PRIVATE PLAN CHANGE 98
ADDENDUM HEARING REPORT
50 PUKEKOHE EAST ROAD AND 47 GOLDING ROAD
OMAC LIMITED AND NEXT GENERATION PROPERTIES LIMITED

Reporting on proposed Private Plan Change 98 - Proposes to rezone approx. 27ha Future Urban Zone to Mixed Housing Urban Zone with a precinct plan and precinct provisions. The land is situated at 50 Pukekohe East Road and 47 Golding Road.

Addendum Section 42A Hearing Report for Proposed Private Plan Change 98: Pukekohe East-Central Precinct 2 to the Auckland Unitary Plan (Operative in part) Section 42A Hearing Report under the Resource Management Act 1991

I45X.9 PUKEKOHE EAST-CENTRAL: PRECINCT PLAN ~~1~~ — Remove "1"

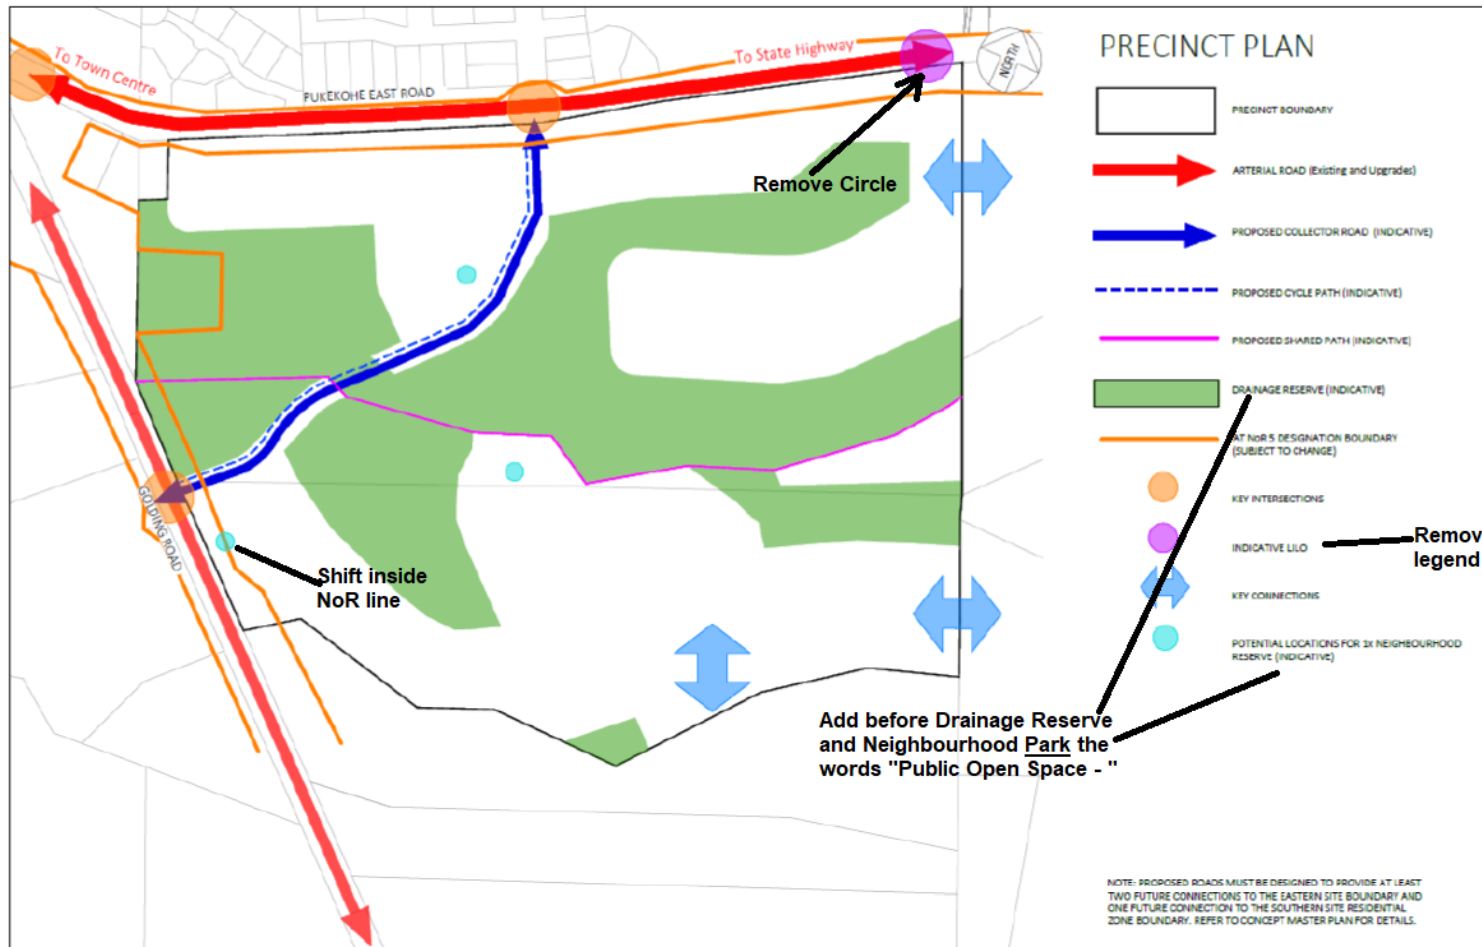
I note that minor changes are also proposed to the Precinct Plan, which I understand are also agreed by the Applicants. These involve:

Park areas indicatively shown on the precinct plan the term “Public Open Space” is added so that there is alignment with the wording used in the provisions.

3. Deleting the reference to “LILO” which is not a term used in the provisions and is redundant on the precinct plan.
4. Deleting the reference to Precinct Plan “1”.

Remove from legend

Add before Drainage Reserve and Neighbourhood Park the words "Public Open Space - "
